Event # 44896

## PART 21 NOTIFICATION - DEFECTIVE HK AND K-LINE CIRCUIT BREAKER TENSION SPRINGS

Subject: Amended Report -- 10 C.F.R. Part 21 Notification of Deviation re. P/N 716539A00 Tension Springs

HK Racking Mechanism Latch

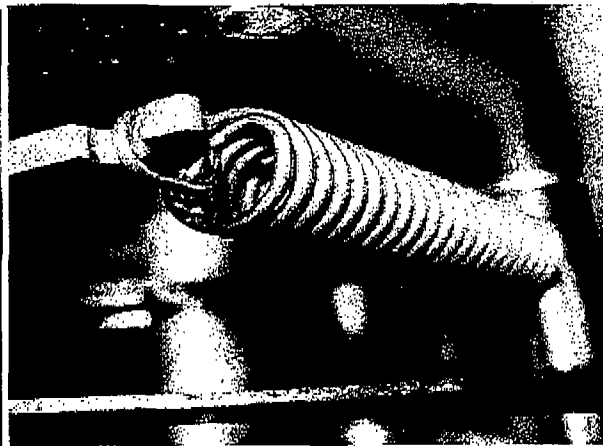
The identification of the Subject component is as follows: ABB P/N 716359A00 Tension Spring. These springs are used in both HK (Medium Voltage) and K-Line (Low Voltage) circuit breakers. In the HK breaker, the spring is used on the racking mechanism to position the racking mechanism interlock latch. In the K-Line circuit breaker, the spring resets the prop latch mechanism following a circuit breaker trip. See photos below:

Nature of the deviation: Micro-cracks in the base of the hooked end of the springs may result in failure of the springs after repetitive cycles. A broken spring could potentially affect the ability of a K-Line or HK breaker to reset and close after an opening operation. Initial report of the nonconformance was generated 2/11/2009 (NCR #68999JL), reporting springs failed during mechanical life testing being performed on a K-Line Breaker. Three springs failed after approximately 2800 cycles each.

Metallurgical analysis of a failed spring concluded that the failure originated in pre-existing cracks in the bend area at the base of the fully formed round hook. Subsequent investigation at the vendor site determined that a production run in April 2008 was manufactured using a different method than prior production runs, in that the fully formed round end of the spring was made using a manual press instead of an automatic hydraulic/pneumatic press. The manual press forming cycle was significantly faster, in that the loop was formed in approximately one second, versus six seconds for the automatic press. Additionally, the manual forming operation was done after tempering and stress-relieving the spring, while the automatic forming occurred prior to tempering and stress relief.

- c. Worked with our vendor, Ace Wire, to determine how future incidents can be prevented and developed quality assurance means to minimize the possibility of a recurrence. As of March 9, 2009, tooling has been polished to minimize tooling marks, and the fully formed hook will be made using the automatic forming machine on future orders.

Given the large number of applications for the affected circuit breakers, ABB (Medium Voltage Service) cannot determine if the potential for a substantial safety hazard exists at any licensee's facility if a similar failure of the tension spring occurs. Licensees are requested to evaluate the history of inspections, maintenance practices, and circuit breaker operating cycles for K-Line breakers, and racking cycles for HK breakers to determine if the circuit breaker spring should be replaced immediately or at the next convenient maintenance opportunity. ABB recommends that any suspect spring with greater than 1400 operating cycles be replaced as soon as possible.

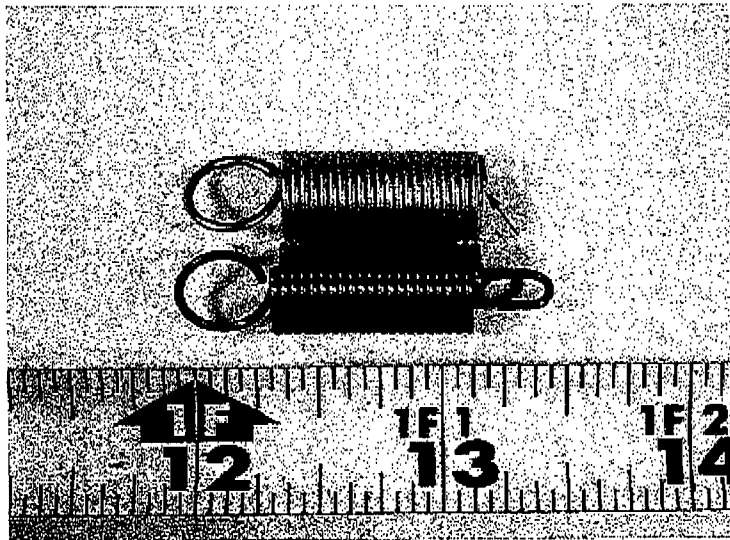
An additional issue was identified during the investigation in that the opposite end rectangular hook had tool marks from the forming operation that could result in premature spring failure. One spring failed after 6000 cycles in the concave bend area at this end. See photo below:

- d. A cycle test has been completed to compare springs produced before and after Ace Wire polished the hook forming tools to validate that the corrective actions are sufficient. To date, 12,000 cycles on (20) springs have been completed, with no further failures. Microscopic inspection has also been done that confirmed the tooling marks have been reduced.
